Comments on #SDP-26-0004 - Planning & Zoning: Site Development Plan

Application Number: #SDP-26-0004
Application Type: Site Development Plan
Date: July 29, 2026
Address: 705 S MAIN ST, ROLESVILLE, NC 27571
Parcel: 1758574058

SITE DEVELOPMENT PLAN - SDP 26-__

REQUIRED VEGETATION PLAN
WALLBROOK SHOPPES (LOT 5C)

C3.1
Date: May 4, 2026

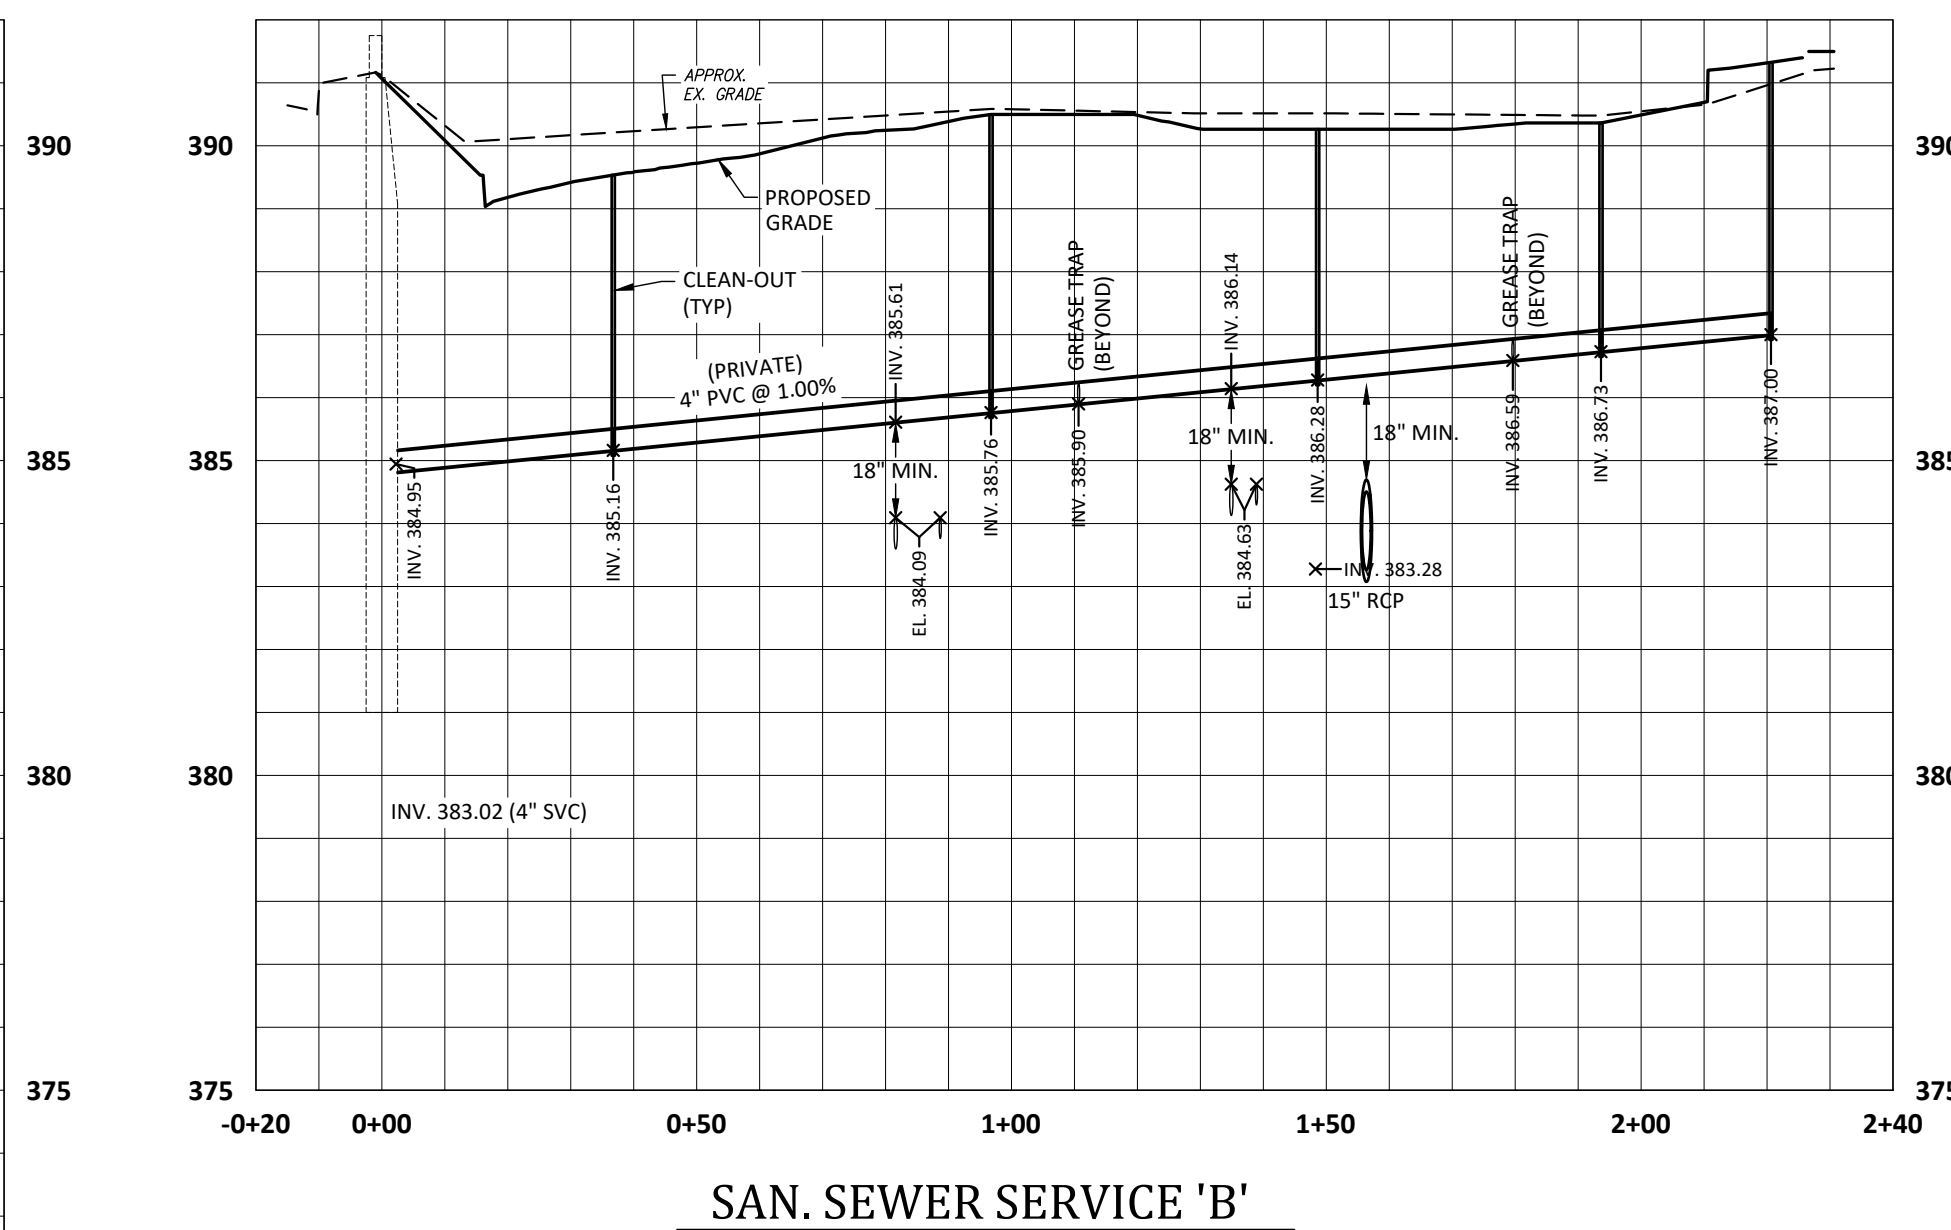
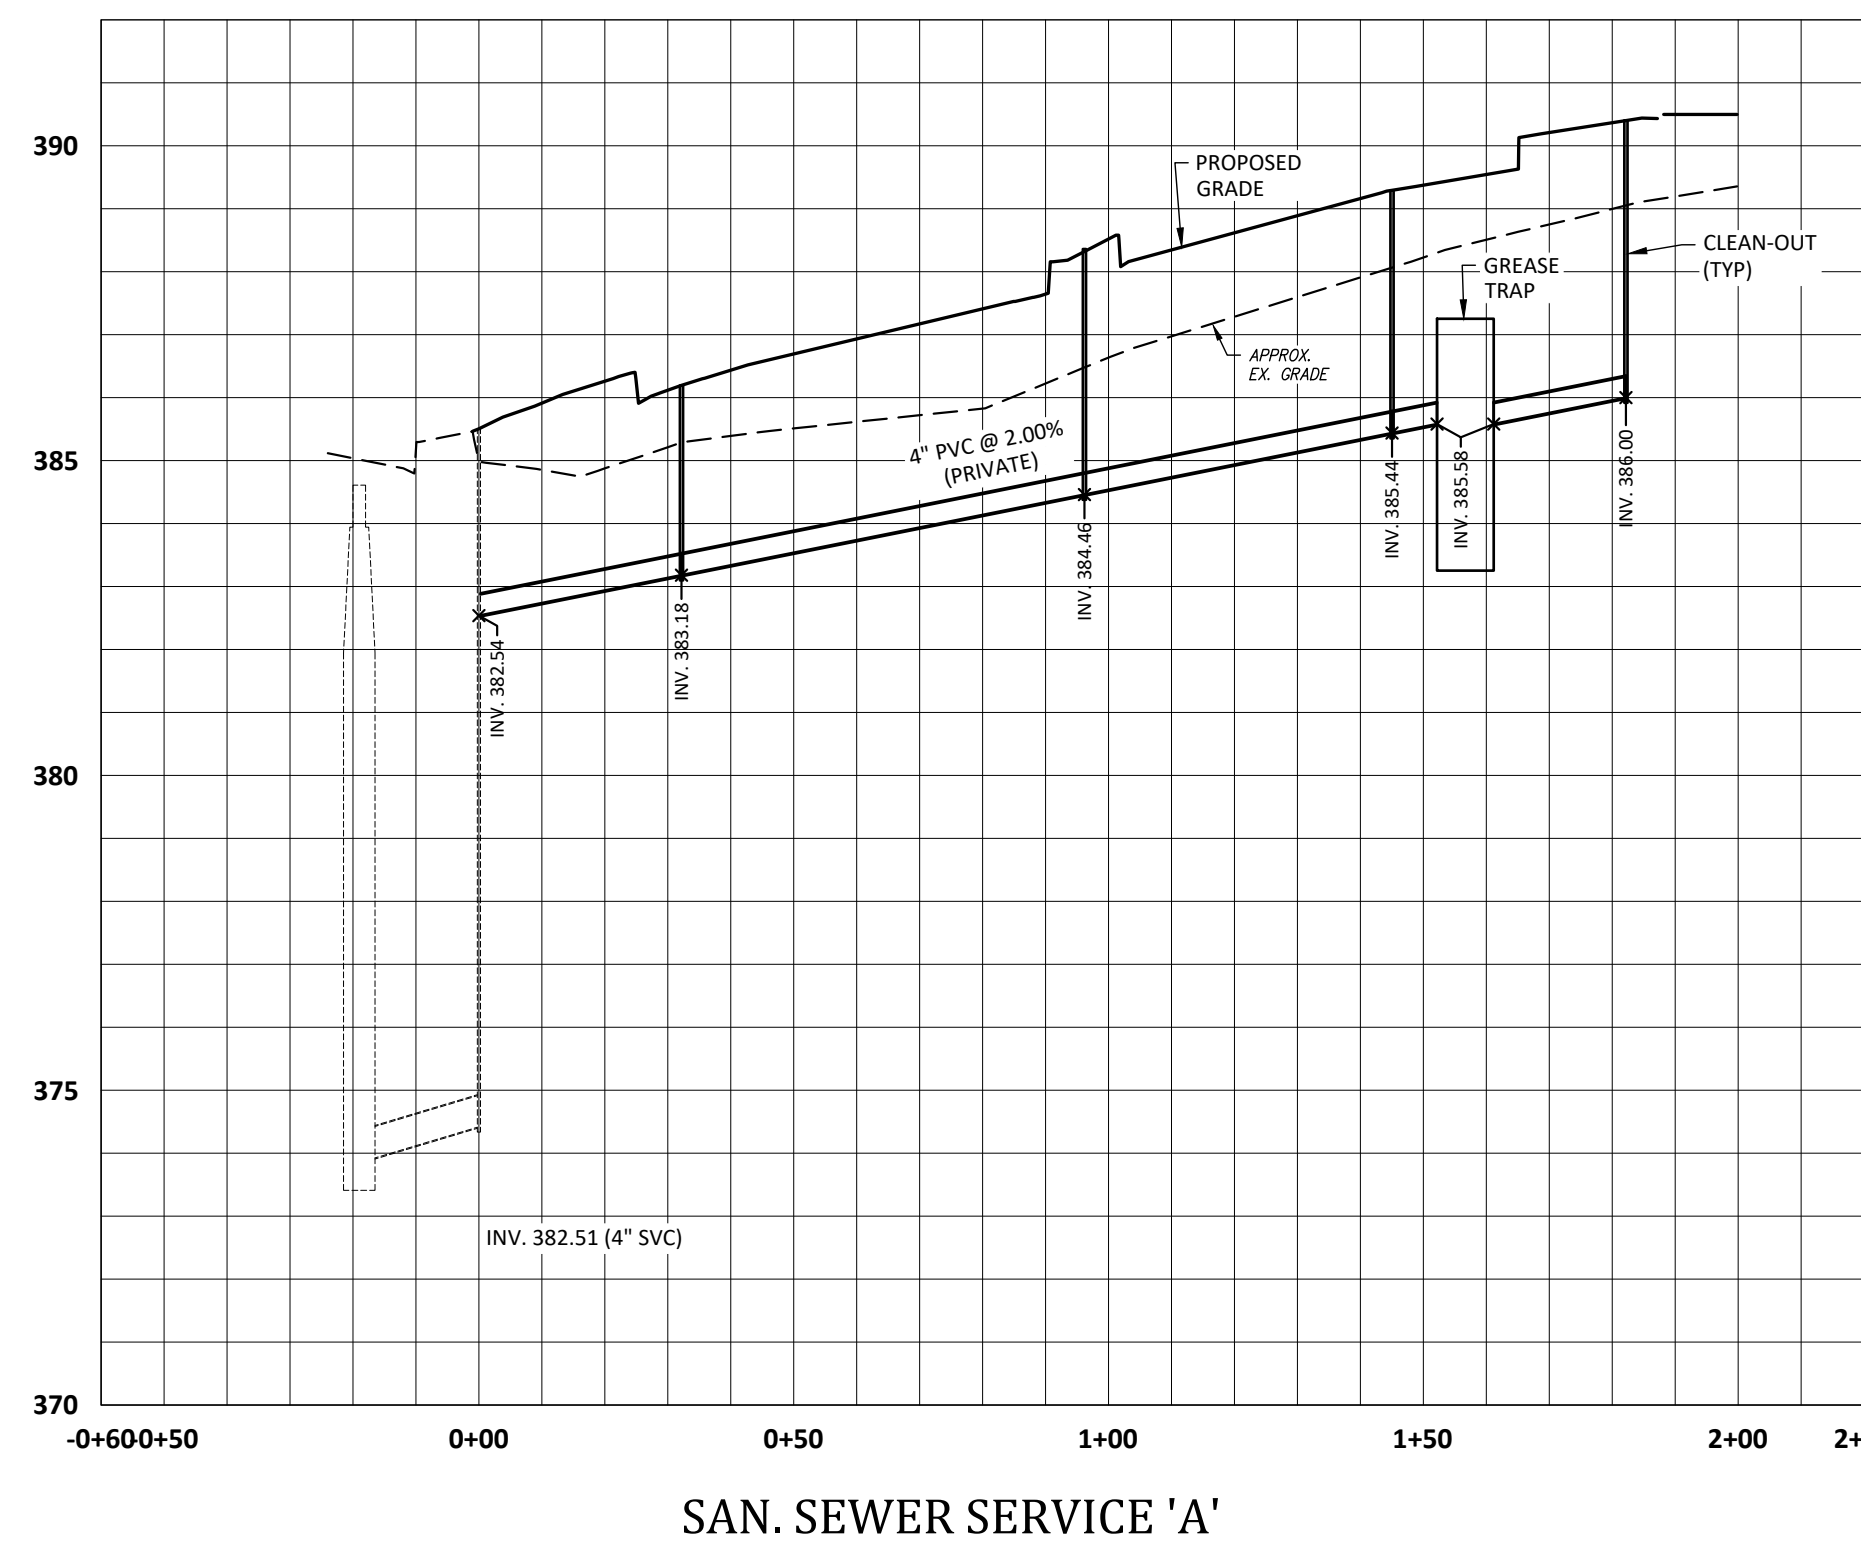
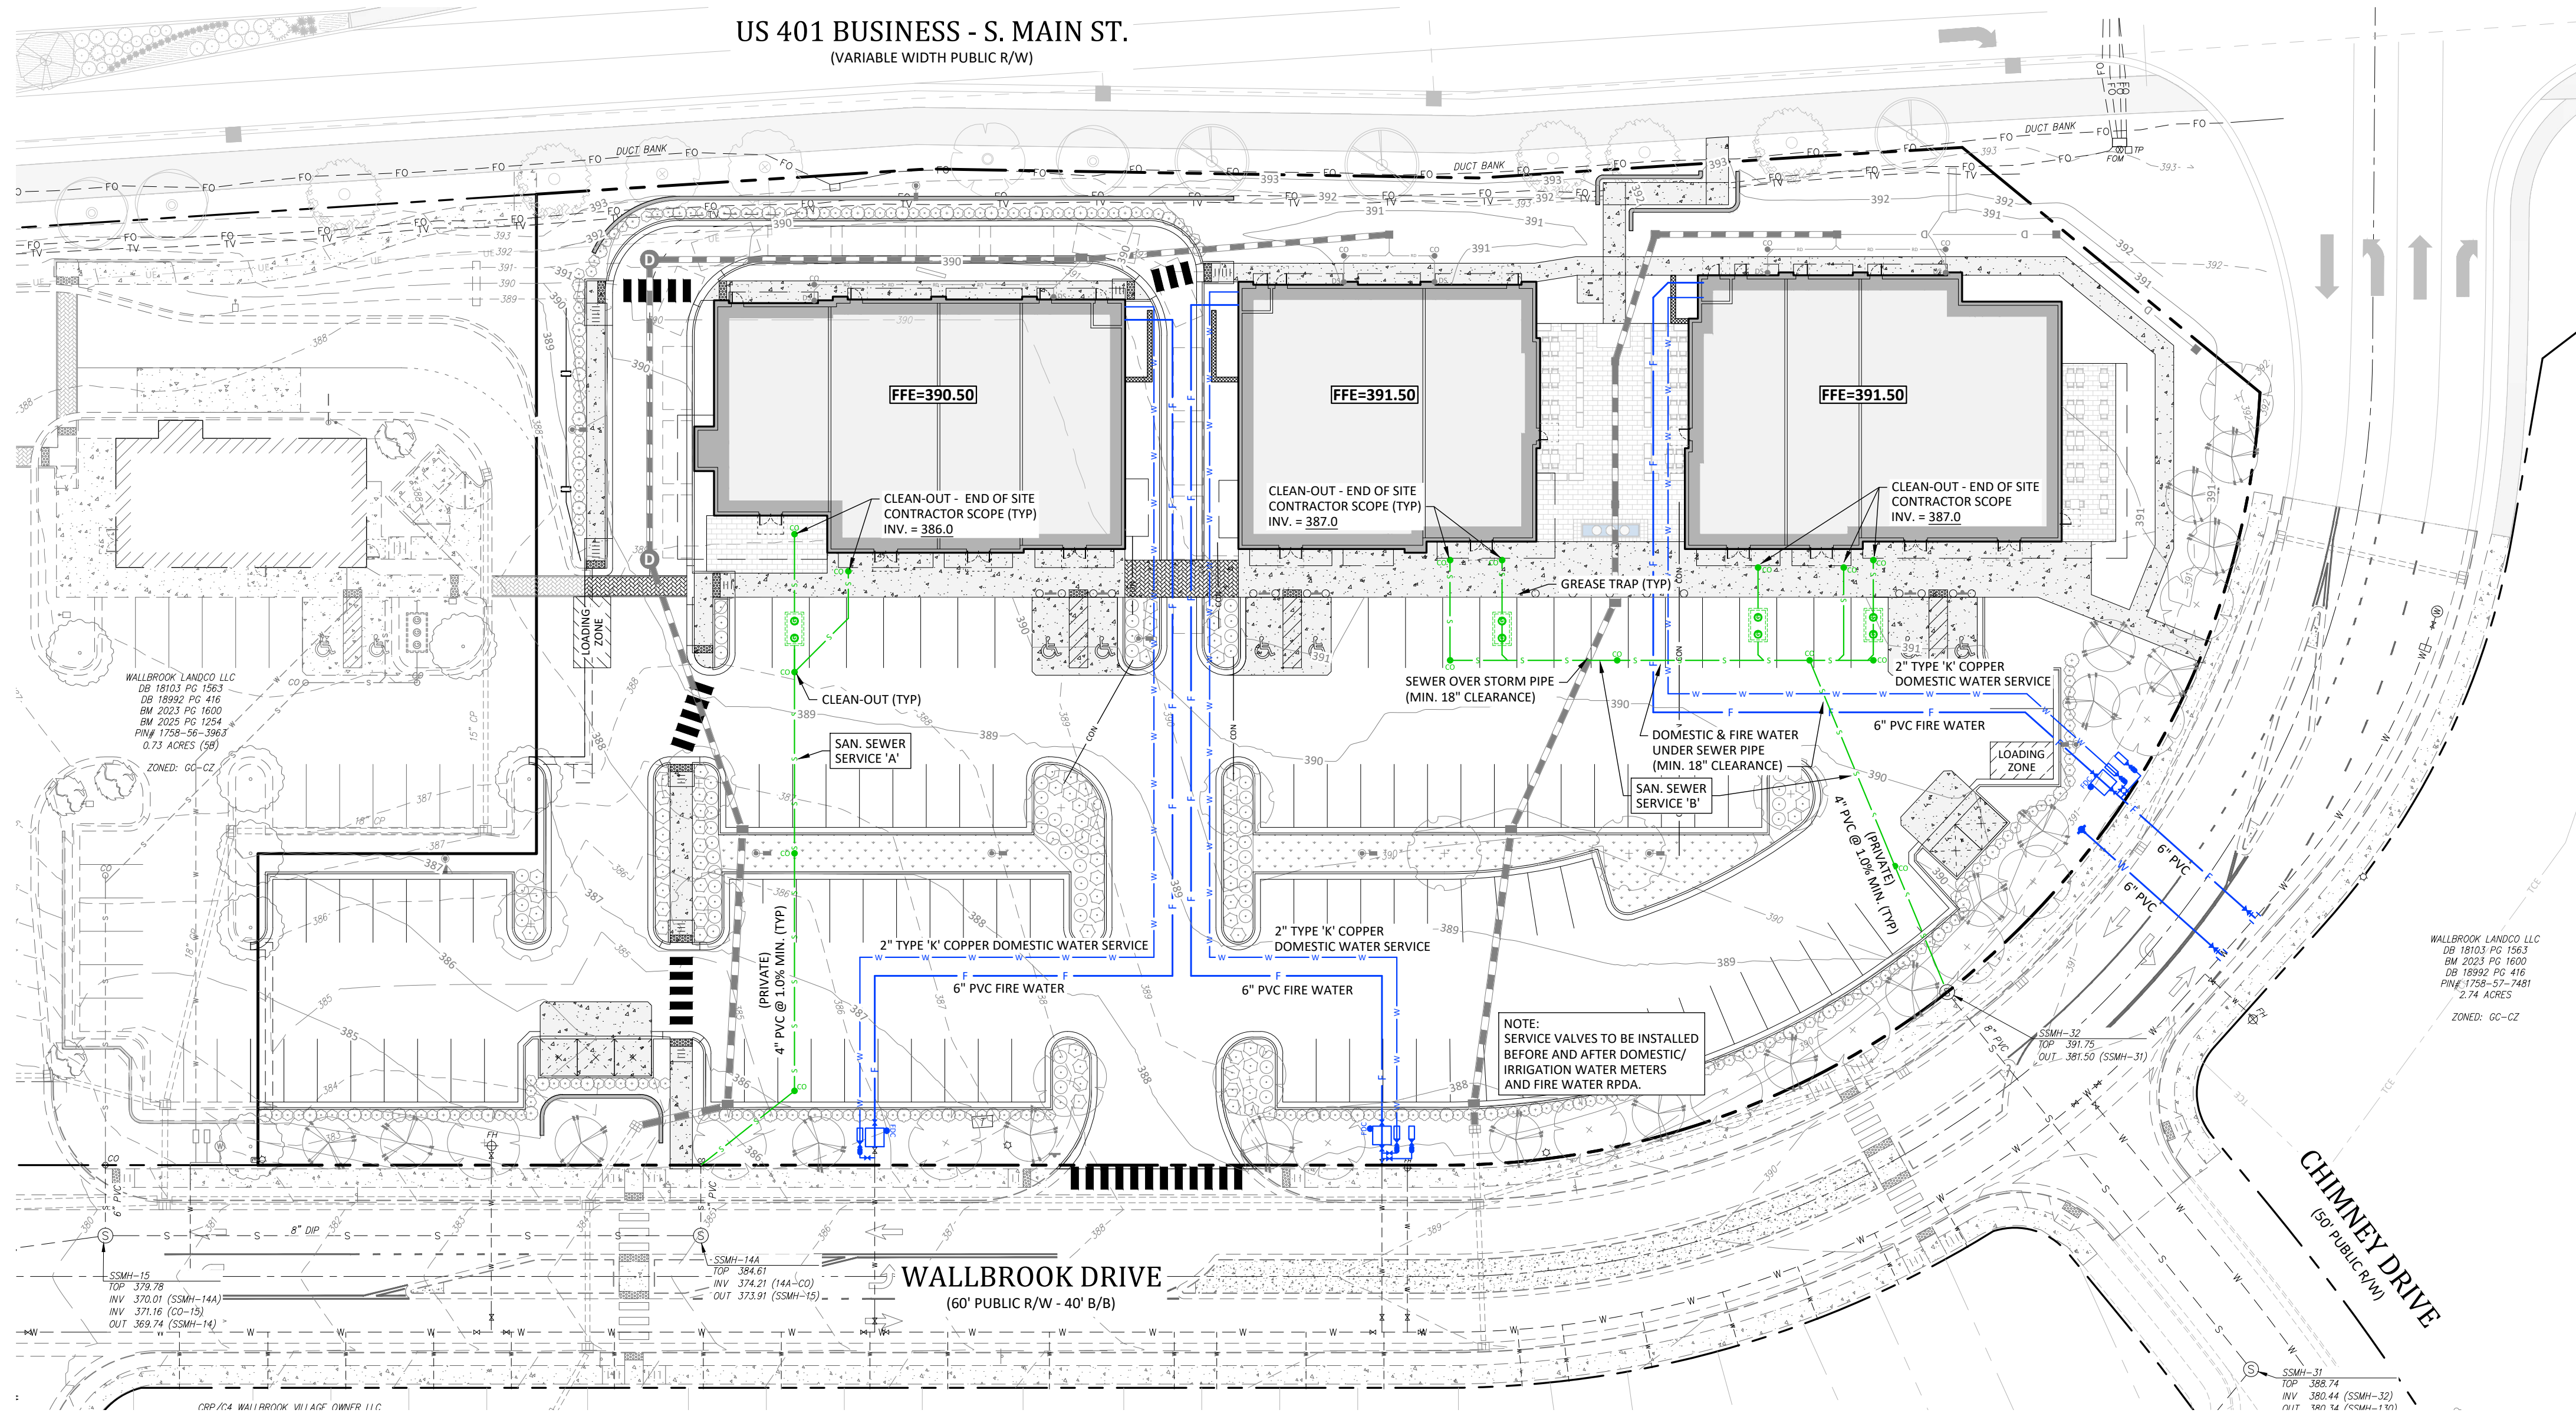
Please include a typical section for bicycle parking with rack details to meet the requirements in LDO Section 6.4.7
- 15** Jacqueline Thompson

Please include width in easement label.
- 16** Jacqueline Thompson
